SIGNATURE POINT

BINDING ELEMENT AMENDMENT

Development Review Committee Meeting
September 16th, 2020

Approved Development Plan 19DEVPLAN1061

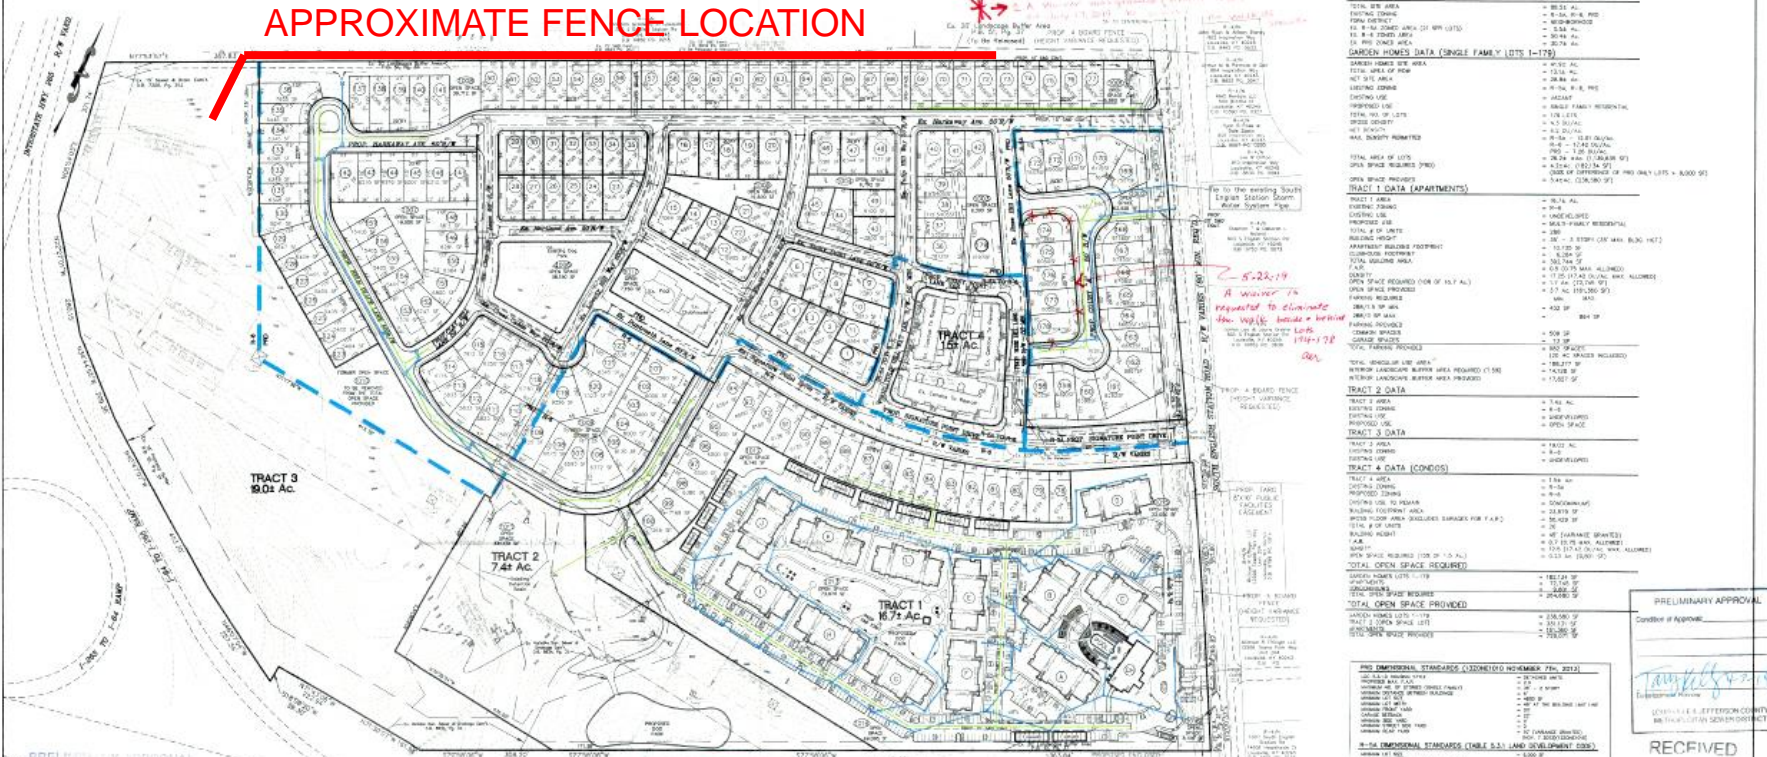
- Current fencing binding element was originally intended to screen a taller more intense development than what is being proposed currently. Both parties (Signature Point developers and Christian Academy of Louisville) have agreed with the proposed change (shown below and on exhibit on next slide).

- **Existing Binding Element #16 (19DEVPLAN1061)**: *“The developer shall, at its expense, construct a 7-foot chain link fence with black vinyl coating with a variety of deciduous and evergreen trees planted along this fence line on 10-foot centers along the entire property line common to Christian Academy of Louisville property. The fence shall be constructed at the earliest of the following times: (A) before construction begins on the buildings along the north line of the subject property; or (B) one year after site work begins anywhere on the subject property. The fence shall be perpetually maintained by the developer or its successor (Condominium Council, Homeowners Association, etc).”*

- **Proposed Binding Element #16**: *“The developer shall, at its expense, construct a 6-foot chain link fence with black vinyl coating as depicted on the attached exhibit.*
